DATE: June 18, 2013

FROM: The Schemmer Associates  
1044 North 115th Street  
Omaha, Nebraska 68154-4436  
Phone: (402) 493-4800  
Telefax: (402) 493-7951

RE: Addendum No. 2 to the Bidding Documents for:  
Boiler Replacement  
VA Project No. 636A6-11-916  
Schemmer Project No. 06054.001

SHEET NO: SDA-5

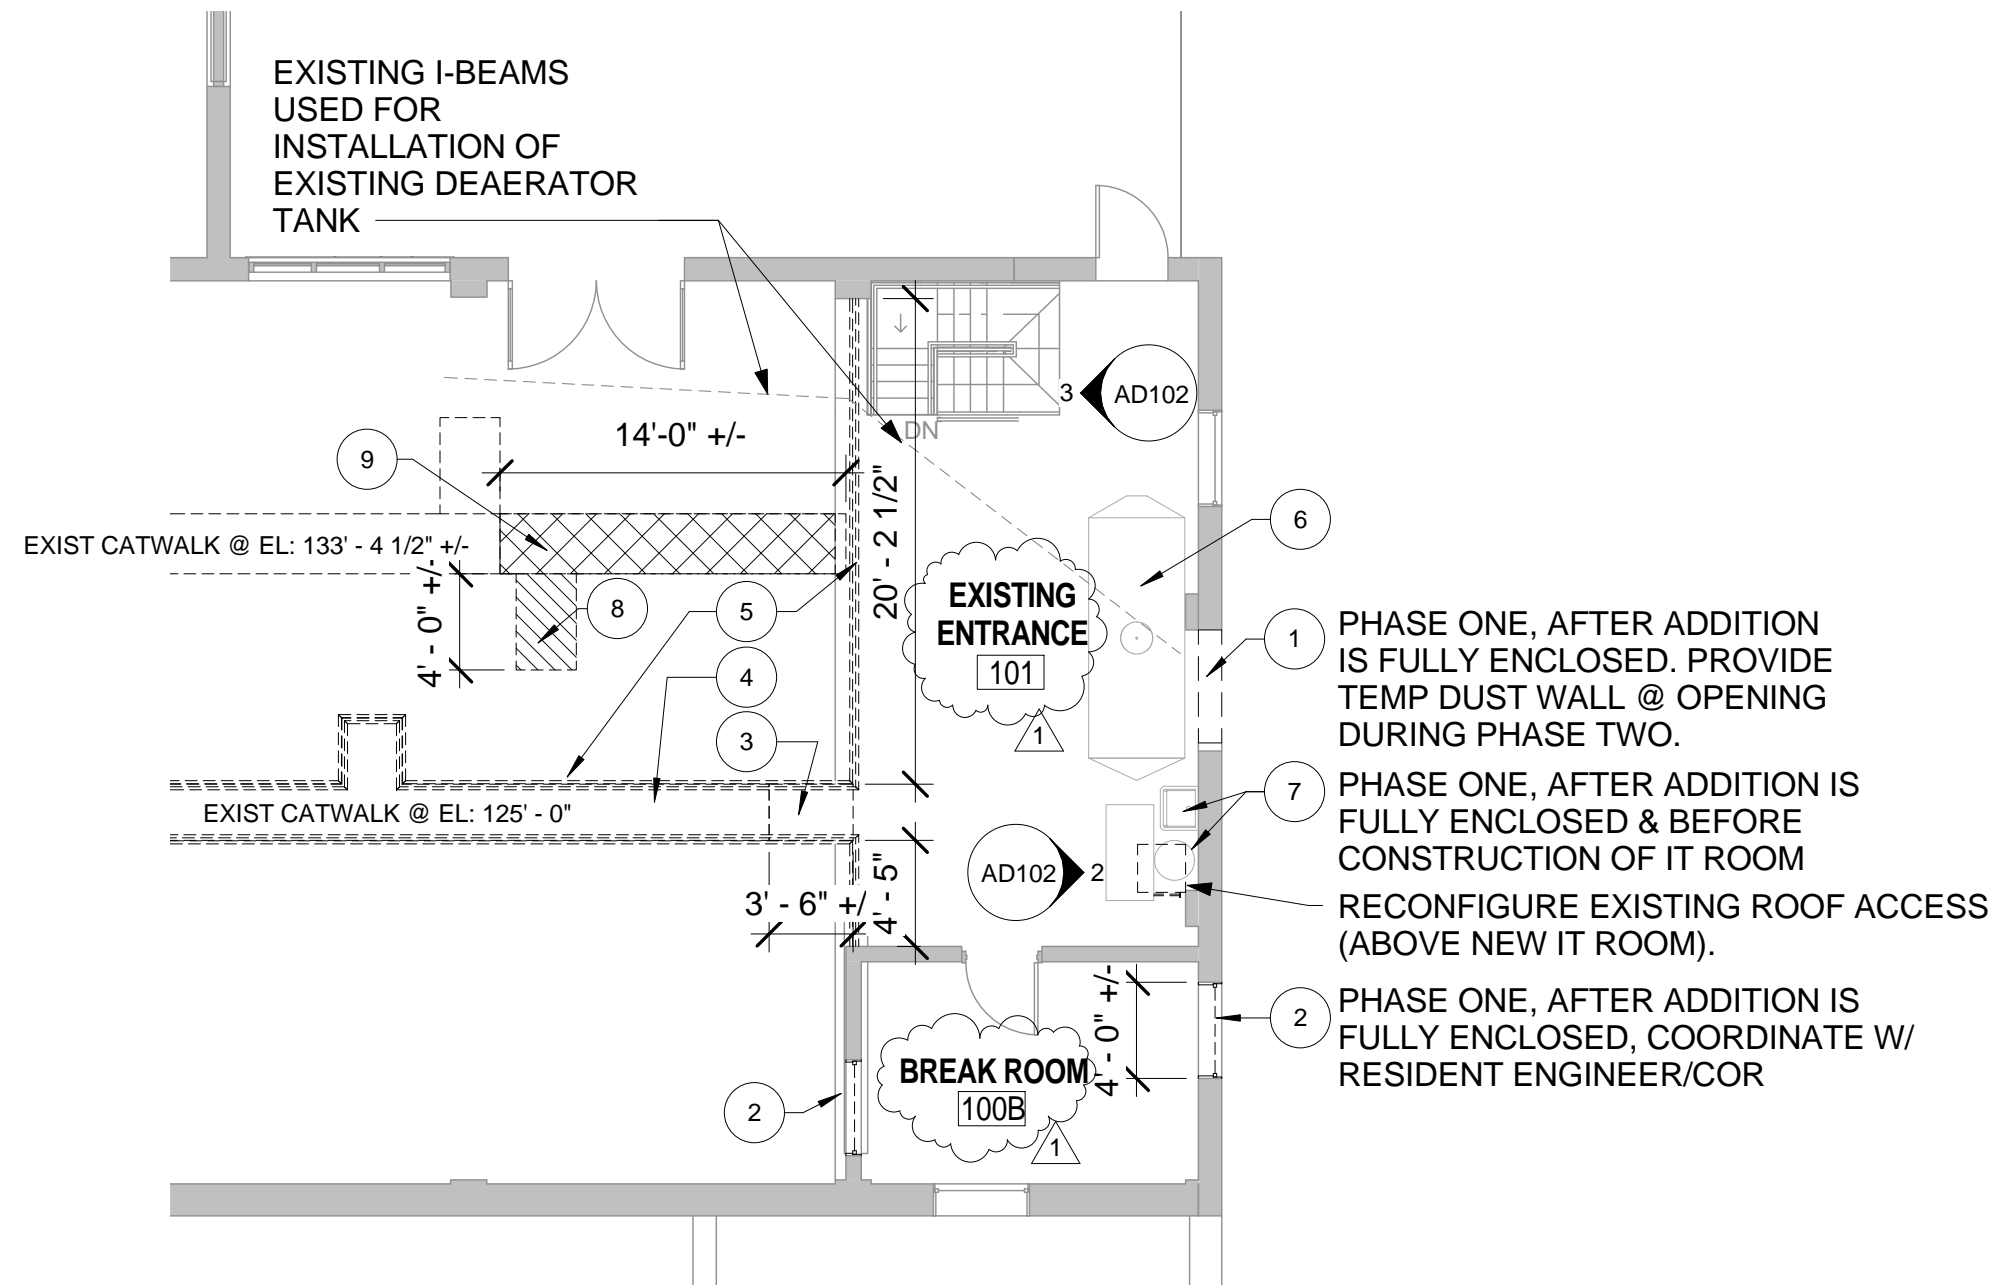
Add Supplemental Drawing SDA-5 (for room name/number references only)

SHEET NO: SDM-3

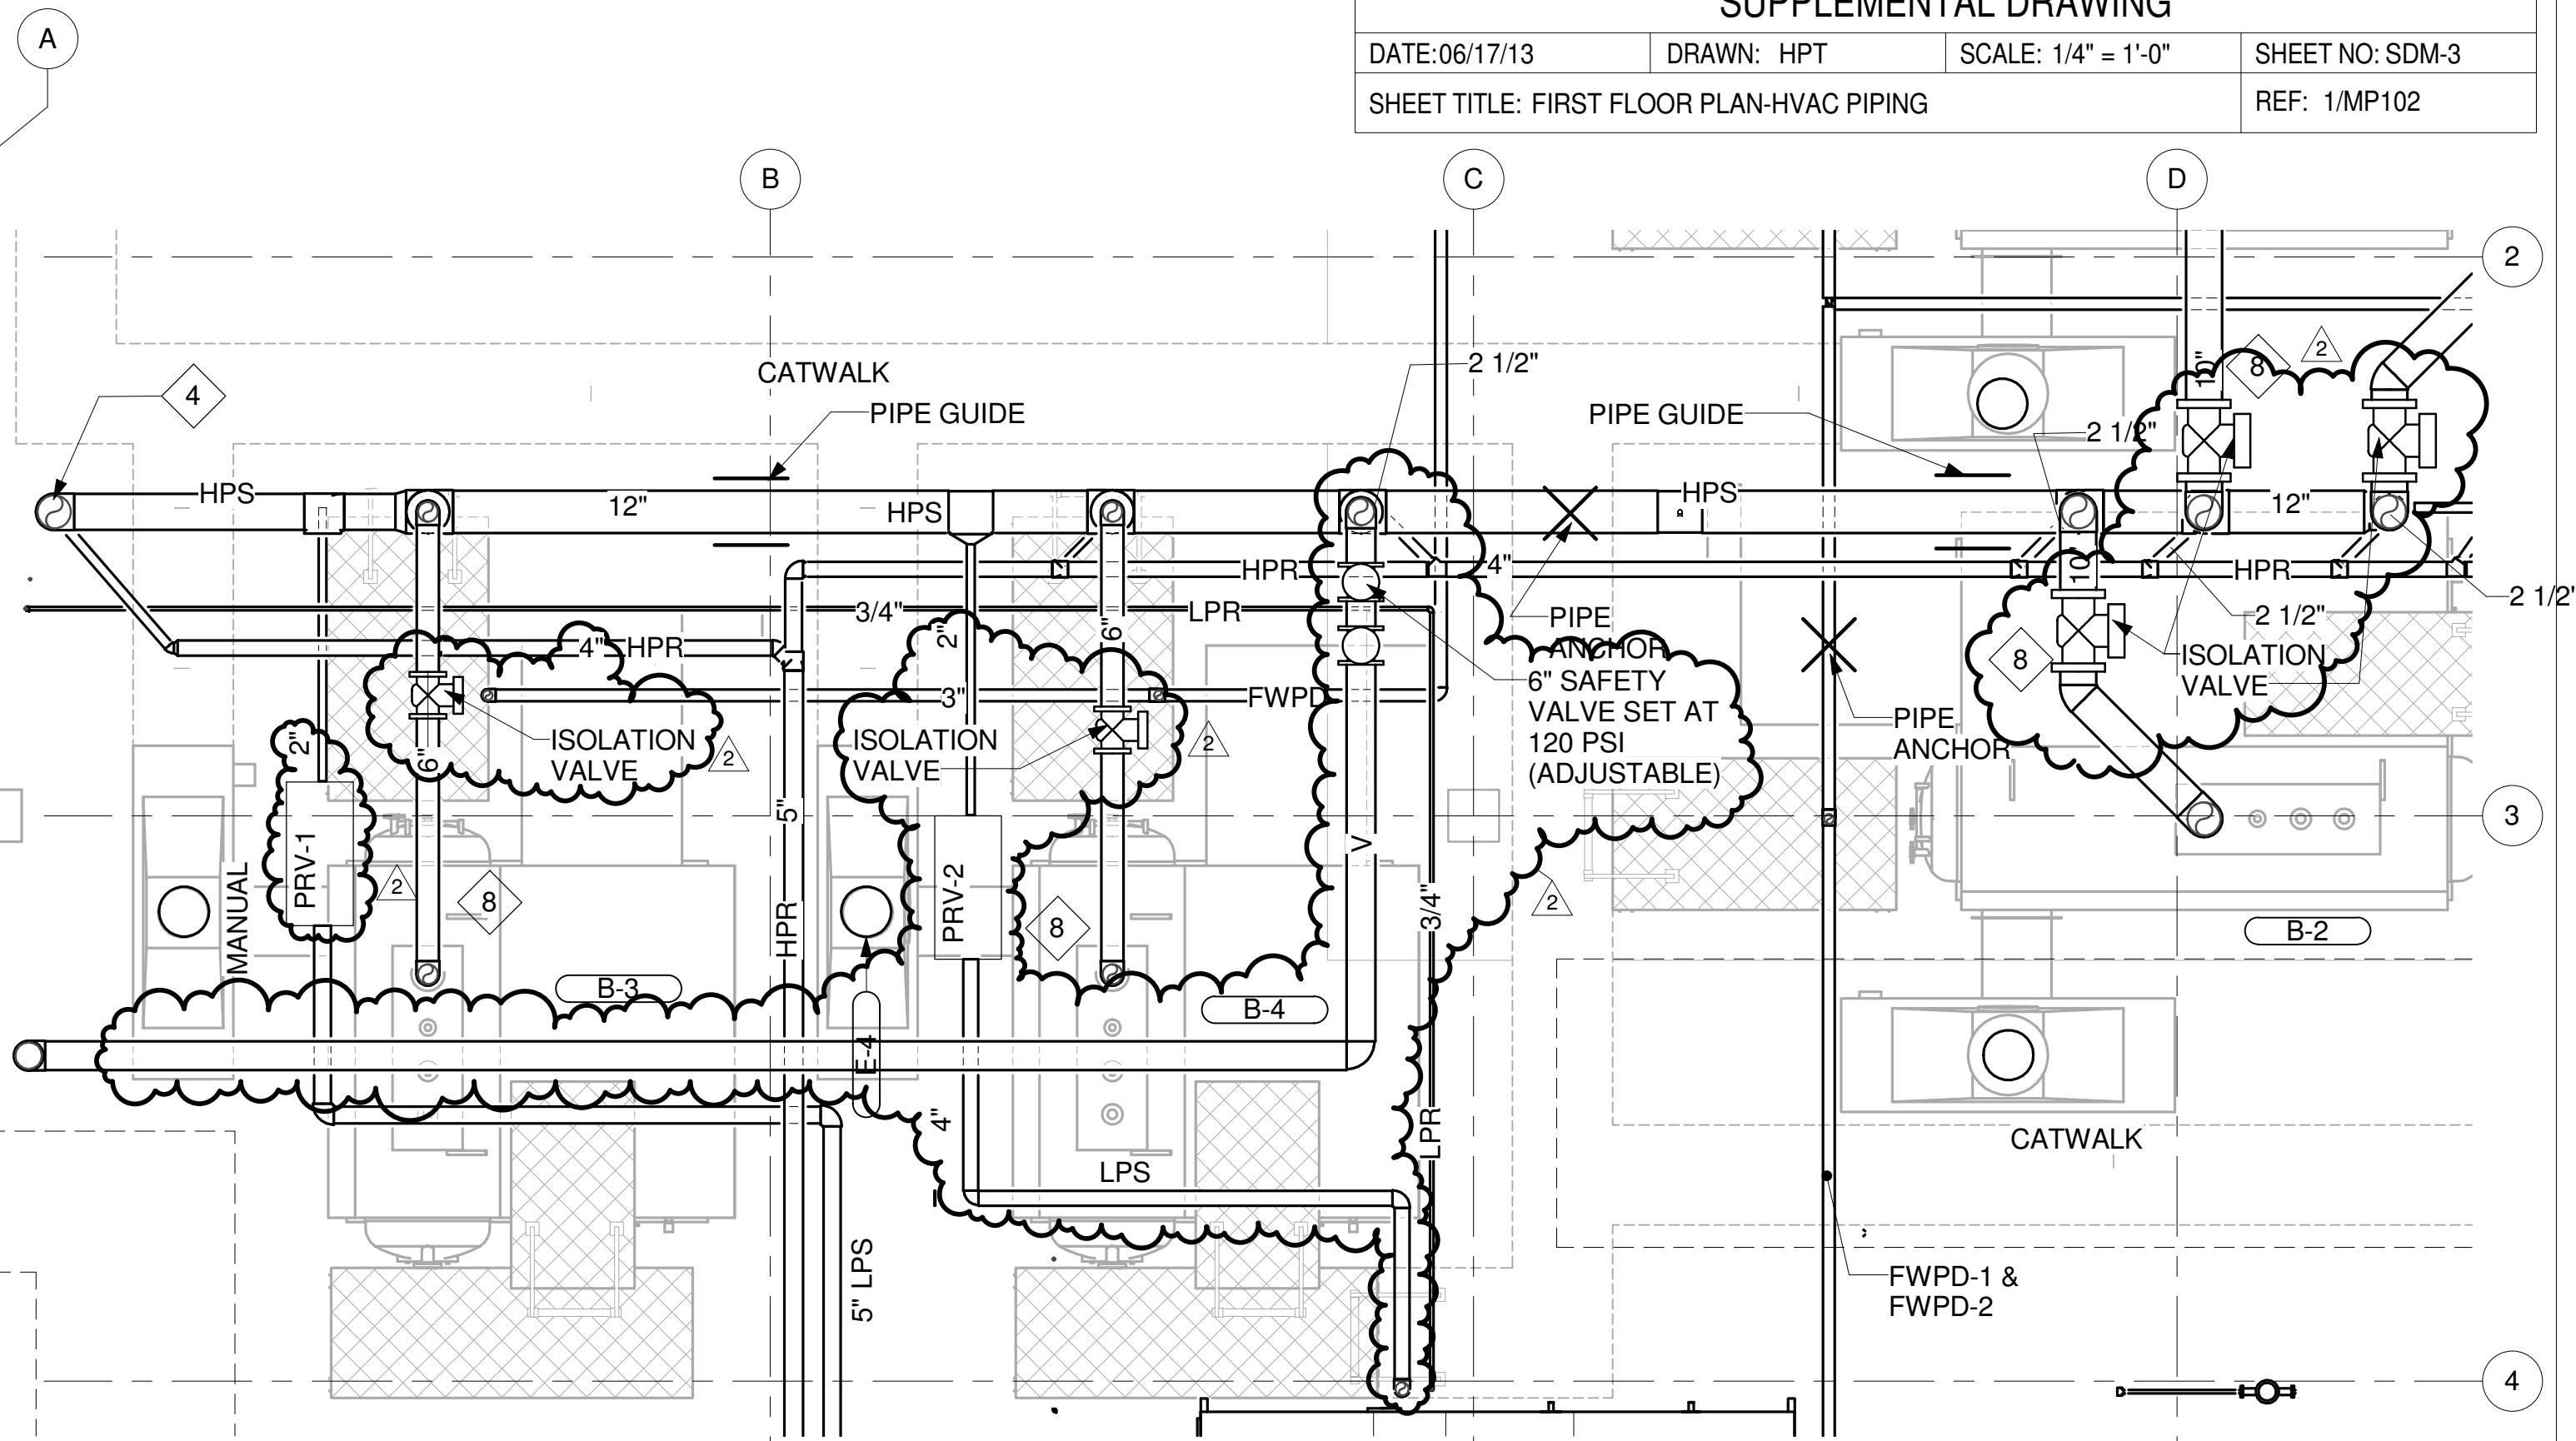
**Question:** How are they controlling the adjustable relief valve off of the main steam header, the one in the current power house is done remotely, also there is no indication of an isolation valve.

**Question:** The drawings indicated a 2 ½" condensate drip leg below each boiler inlet to the main steam header three (3) of the inlets are less than four (4) feet apart, is this necessary, also there is no indication of trap size on the drawings.

**Question:** There is no indication of pipe size for the low pressure steam feeding the PRV station nor the size of the PRV's.

**Answer:** See Supplemental Drawing SDM-3 for isolation valve at relief valve. Provide an electronic actuated valve to control SVS-1, steam safety valve, through Metasys control system.

**Answer:** See Supplemental Drawing SDM-3 for removal of the 2 ½" condensate drip leg at each boiler inlet to the main steam header and Supplemental Drawing SDM-4 for steam trap sizes.

**Answer:** See Supplemental Drawing SDM-3 for LPS pipe sizes and Supplemental Drawing SDM-4 for the PRV schedule.

DATE: 06/07/13	DRAWN: ACS	SCALE: NONE	SHEET NO: SDE-1
SHEET TITLE: EXTERIOR DOOR SECURITY DETAIL			REF:

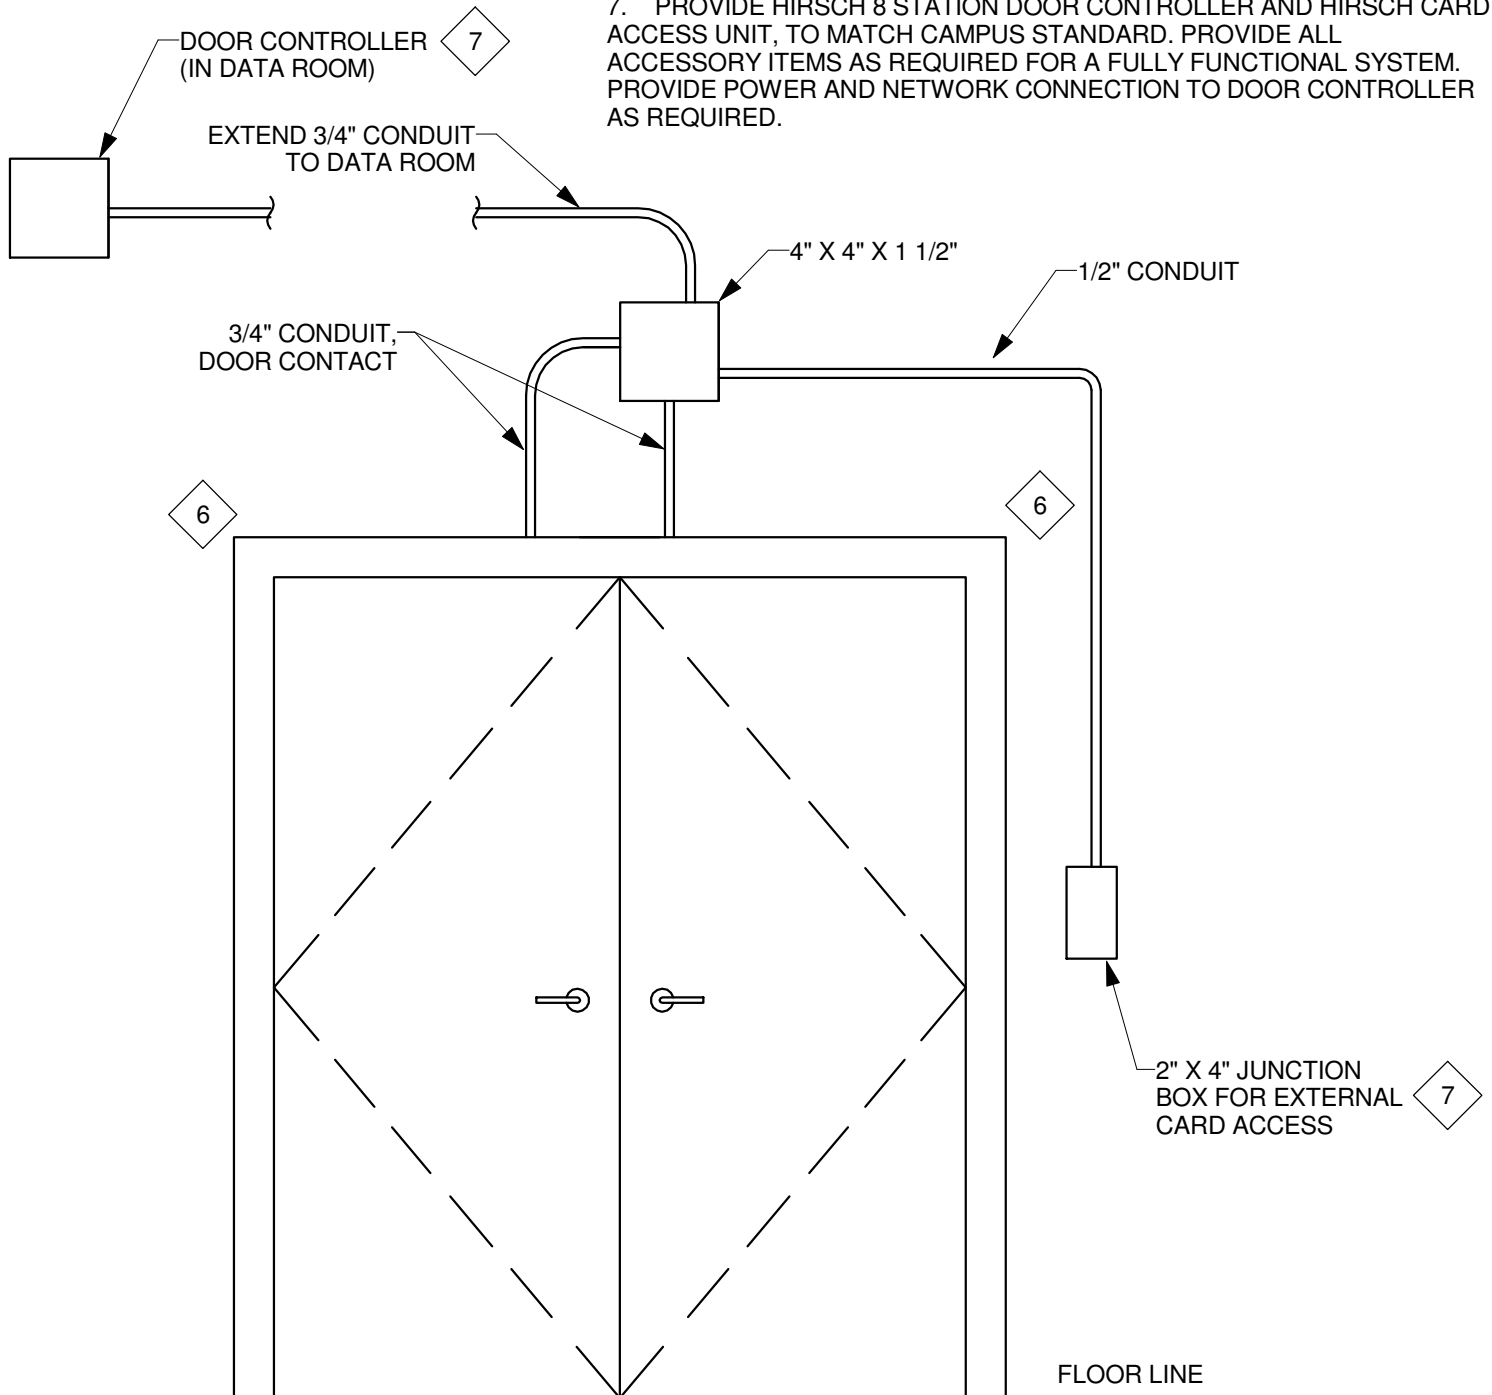
Supplemental drawing SDE-1 as referenced in addendum one is included in this addendum.
